**\*MANDATORY SERVICE BULLETIN\***

**NUMBER:** SB11-06  
**REVISION:** 01  
**DATE:** 06/01/2011

**SUBJECT:** RUDDER TRIM MOTOR INSPECTION

Figure 1-1: Rudder Trim Motor Inspection and Drilled Head Screw Replacement

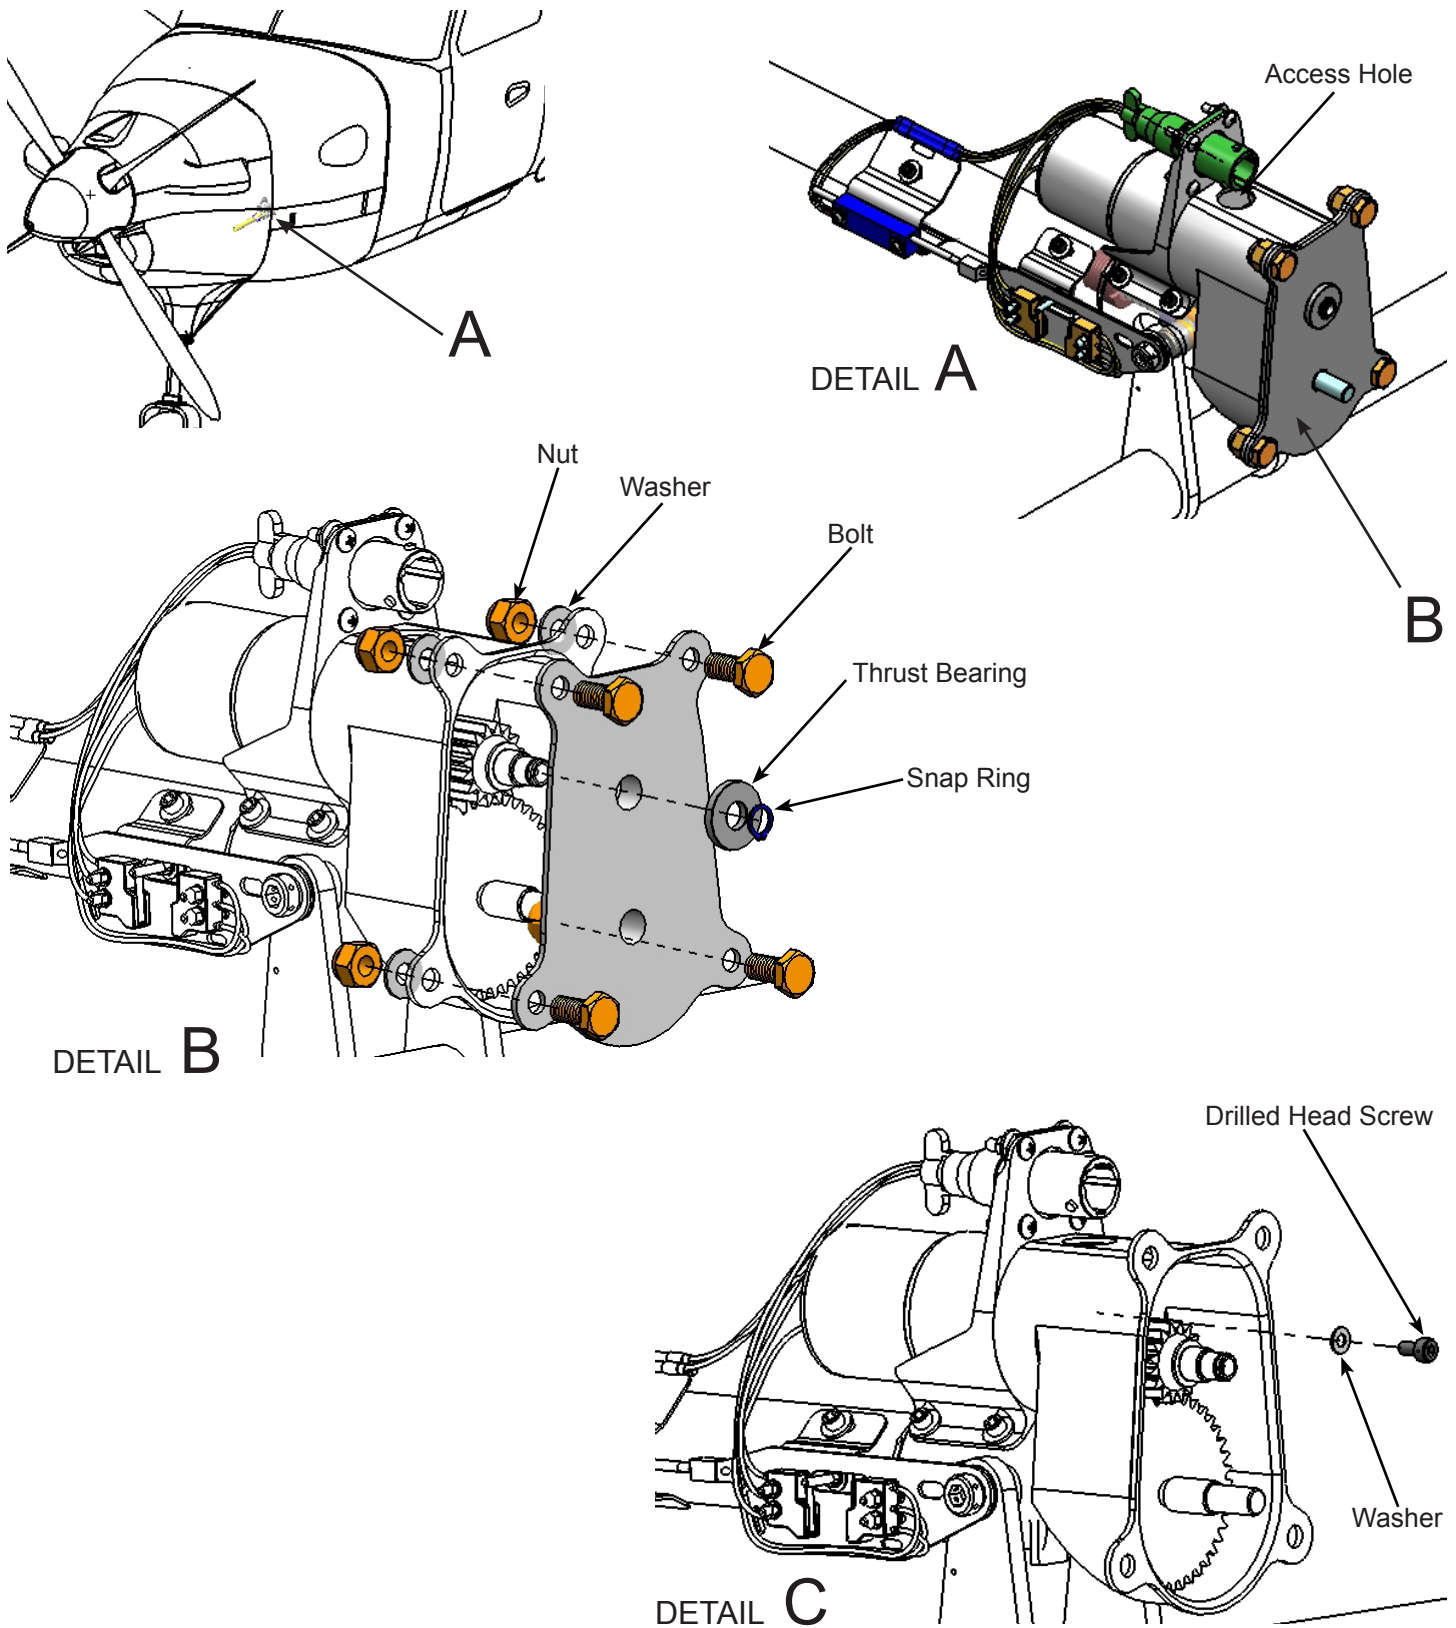
Quest is mandating a one time inspection of the screws securing the rudder trim motor to the rudder trim gear box housing. Refer to **Figure 1-1**.

1. Turn the master switch to the *OFF* position.
2. Disconnect the electrical connection located at the top of the rudder trim motor assembly as shown in **Figure 1-1, Detail A**.
3. Using a bright light, inspect the screws securing the rudder trim motor (P/N **100-820-6175**) to the rudder trim gear box housing (P/N **100-617-2182**) through the access hole in the top of rudder trim gear box housing (P/N **100-617-2182**).
  - A. If drilled head screws are present, reconnect the electrical connection located at the top of the rudder trim motor assembly and contact Quest Customer Service for three (3) replacement parts (P/N **NA0274-030006**). Once replacement parts have been obtained, proceed to **Section 2**.
  - B. If the screws have non-drilled heads, reconnect the electrical connection located at the top of the rudder trim motor assembly and proceed to **Section 3**.

4. Remove the snap ring (P/N **MS16624-1025**) and thrust bearing (P/N **MTI-04**) securing the rudder trim gearbox cover plate (P/N **100-617-2183-D01**) to the pinion drive motor, and remove the rudder trim gearbox cover plate (P/N **100-617-2183-D01**). Refer to **Figure 1-1, Detail B**.

5. Individually remove the three (3) screws (P/N **NA0274-030005H**) and three (3) washers (P/N **MS15795-803**) securing the small gearbox (P/N **100-820-6175**) to the mounting bracket (P/N **100-617-2176**). Apply a thread fastening/sealing agent, and reinstall the replacement screw (P/N **NA0274-030006**) and washer (P/N **MS15795-803**) before proceeding to the next screw.
